SEGA SERVICE

Field Service Bulletin Strike Fighter Deluxe Important Notice !!!

Assembled Joystick

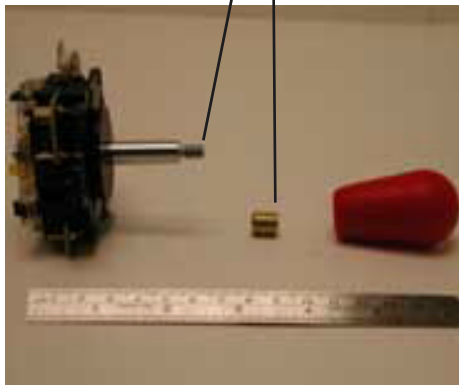
Problem: The Joystick used for the direction control (Camera Angle) on the Strike Fighter Deluxe is threaded and may come loose.

Apply Loctite at these points

Solution: See the pictures below and install Blue Loctite (242) on the locations indicated ASAP.
